**PLANNING, ZONING, & BUILDING DEPARTMENT**  
**PZ&B Staff Combination Memorandum: Architectural Commission and Town Council**

**SUBJECT:** ARC-24-0085 (ZON-24-0044) 315 CHAPEL HILL RD

**MEETING:** JANUARY 29, 2025, ARCOM  
FEBRUARY 12, 2025, TC

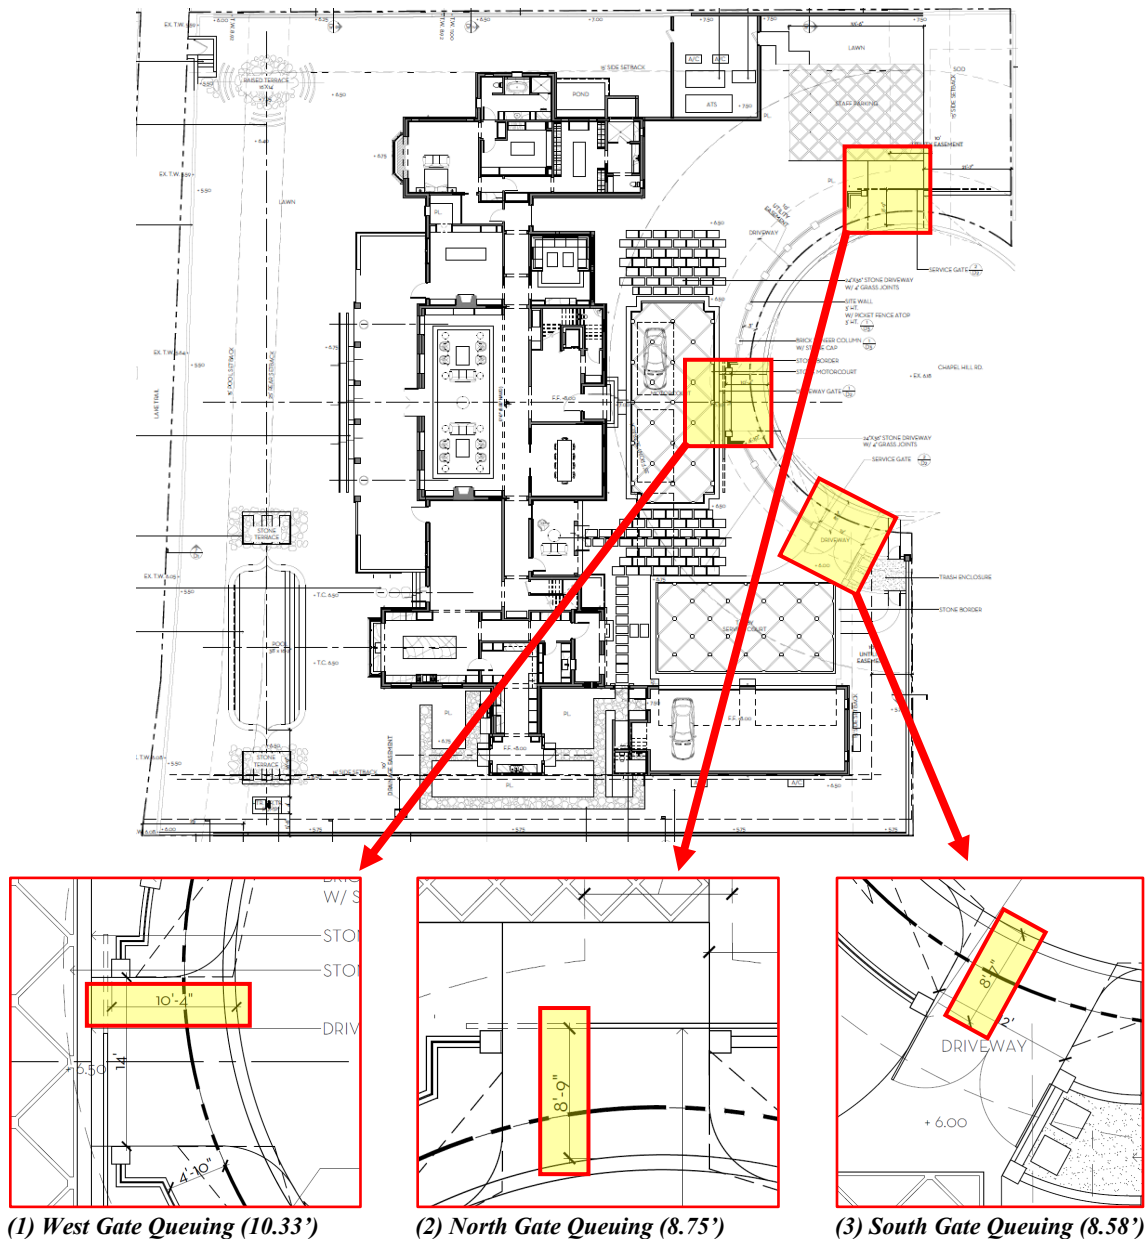
The application was originally heard at the November 2024 ARCOM hearing and was deferred for further study of scale and massing, especially as it pertained to appendages of the main structure. Overall, the project was well received by the commission. The applicant resubmitted plans in response to comments of the commission, with modifications to building footprint, roof eave height, ridge height, gable ends, massing, and other architectural details. The attached two-car garage previously proposed at the north of the structure has been eliminated from the design. Landscape and hardscape plans were also adjusted according to the modifications to the structure, including relocation of a vehicular gate and elimination of the pedestrian gate.

The proposed main house is sited roughly center on the parcel with a two-story detached four-bay garage structure proposed in the southeast corner of the site. The site is proposed to be surrounded by site walls and accessed by one of three vehicular curb cuts, all with gates. Open and covered terraces are proposed at the rear of the main structure overlooking an expansive lawn and the Lake Worth Lagoon. A swimming pool is proposed in the southwest rear yard and a paved terrace is proposed at the northwest rear yard. The residence is designed with a primarily two-story volume spanning from the south to north side yards with a small one-story “clipping room” projection on the south side of the structure. The structures feature sloped roofs contained by parapeted gable ends. Exterior details include whitewash brick at the main house with lime wash brick at the wings. Roof types are a shake shingle over the main structure and garage structure with standing seam copper roofs at the projections (bay windows, covered entry, etc.). Windows are proposed in steel or painted wood. An acid washed limestone trim is proposed. Shutters are shown in a green color and a stained mahogany wood door with divided light pattern with transom is proposed for the main entrance.

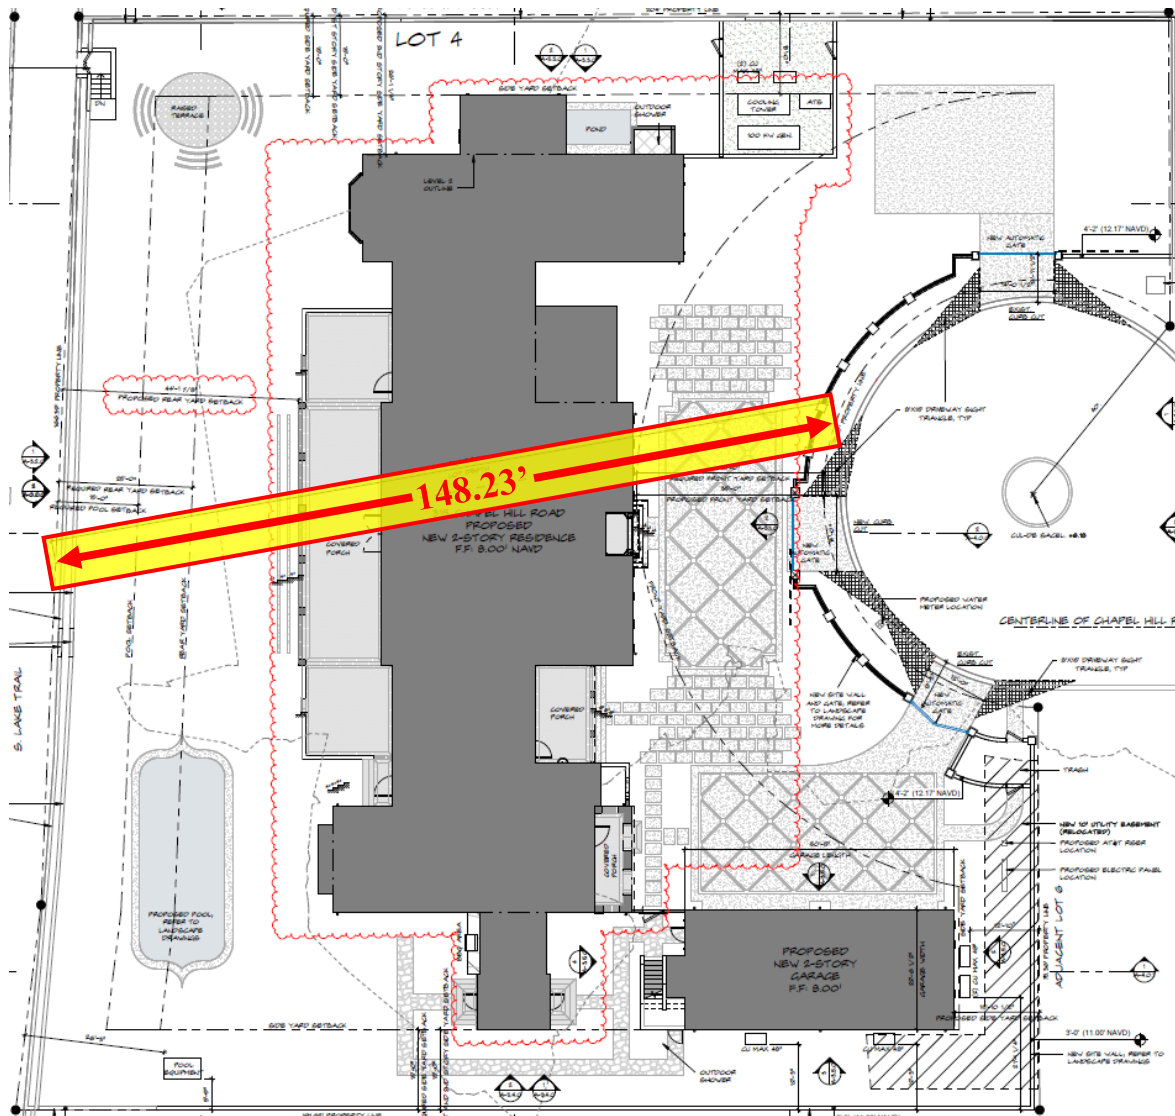
The proposed gates do require review and approval by Town Council. **Special Exception # 2** pertains to the setback distance of the vehicular gates from the Chapel Hill Road right-of-way. The zoning code requires that an 18'-0" deep vehicle queuing space be provided between the vehicle gate and the edge of the pavement to prevent a car from obstructing the roadway while waiting for the gate to operate. However, when the proposed gates are located on a cul-de-sac street, the Code permits pursuing a special exception for reduced queuing area (in lieu of a variance as would be required on a through-street). The existing residence on site has three curb-cuts all with vehicular gates. In addition to the subject parcel, one other residence on the street has a vehicular gate.

Code Section	Required	Existing/Proposed	Difference
SPECIAL EXCEPTION 2: Sec. 134-1668	18' Vehicle Loading Space at Drive Gate	10.33' (1) West Gate 9.25' (2) North Gate 8.58' (3) South Gate	-7.67' (1) West Gate -8.04' (2) North Gate -9.42' (3) South Gate

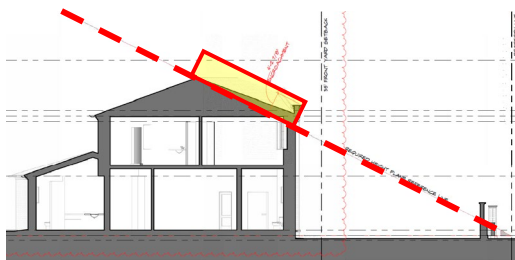
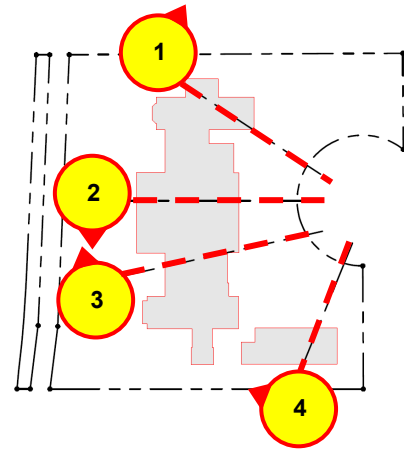
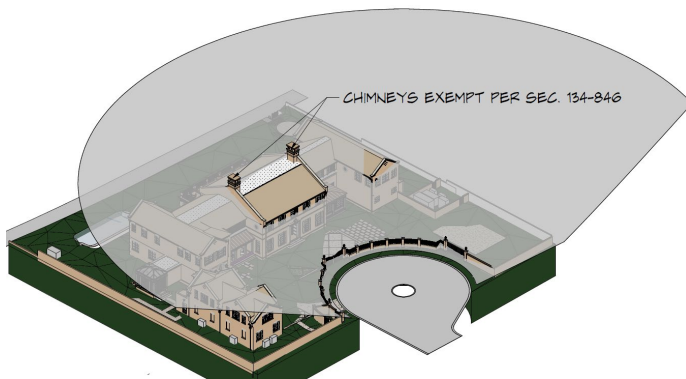
**Special Exception # 1** pertains to the depth of the lot. The lot is an irregular shape with a concave arc along the front property line as it follows the shape of the cul-de-sac. Due to the zoning code definition of lot depth, the point where to measure the depth of the lot is along this arc, resulting in a lot depth of less than 150'-0" which is the minimum lot depth required for the R-A zoning district. If the lot depth was to be measured along the north or south property lines from east to west, the depth would be conforming at approximately 200'-0". To note, the requested special exception is for an irregularly shaped lot that is only 1.77' deficient at its shaped most pinched point.

Code Section	Required	Existing/Proposed	Difference
SPECIAL EXCEPTION 1: Sec. 134-843(b)	150' Lot Depth	148.23' Lot Depth	-1.77' Lot Depth

*Building height plane encroachment 1 (4.24')*

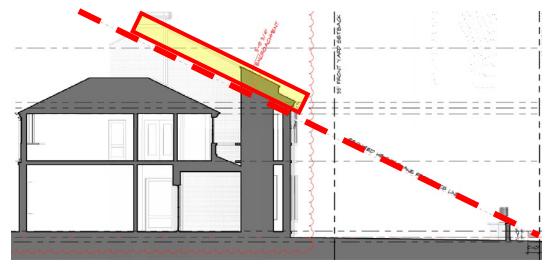
As it pertains to the **Variance** request, the applicant is proposing to construct the new residence beyond the building height plane limitation. The code states that no portion of any building or roof system shall extend beyond a height limiting plane extending at an inclined angle from the intersection of the front yard property line and zero datum. To determine the angle of the building height plane, two feet of setback are required for every one foot in building height. Due to the peculiar shape of the lot, the building projects anywhere between 3.48' to 5.21' beyond the building height plane.

Code Section	Required	Variance
VARIANCE 1: Sec. 134-843(7)	2' setback for every 1' building height	+3.48' – +5.21' Encroachment
